Notice of Allowability

10/502,329

KOTTER LENDERS

EXAMINER'S AMENDMENT

FIG. 4.

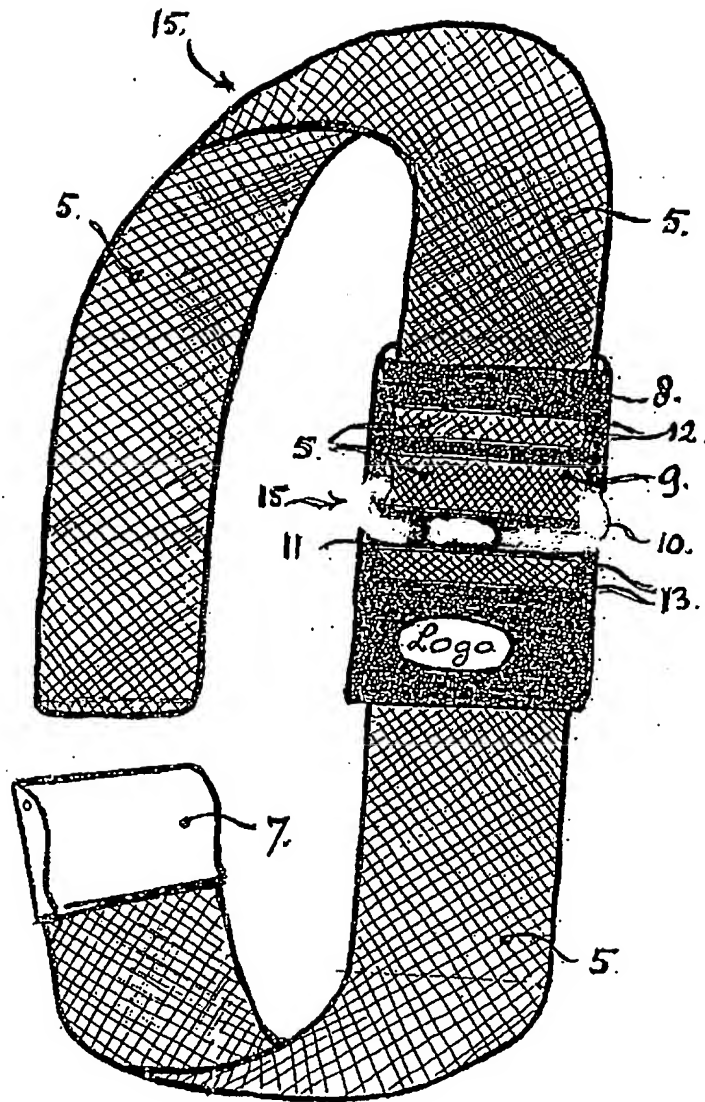
j. In the paragraph beginning at page 5, line 15 as amended 2/28/07, in line 17, "(not indicated)" was changed to, --as well as a round wire through a bore (shown schematically in Figure 4). The locking mechanism is one of stainless steel and

2. The following changes to the drawings have been approved by the examiner: In Figure 4 of the replacement drawings, the hatching on lock 11 will be deleted, as lock 11 in Figure 4 is now a schematic showing of the hook, wire, etc. In order to avoid abandonment of the application, applicant must make these above agreed upon drawing changes.

*Drawing
Change
Approved*

Approved
EL
3/12/07
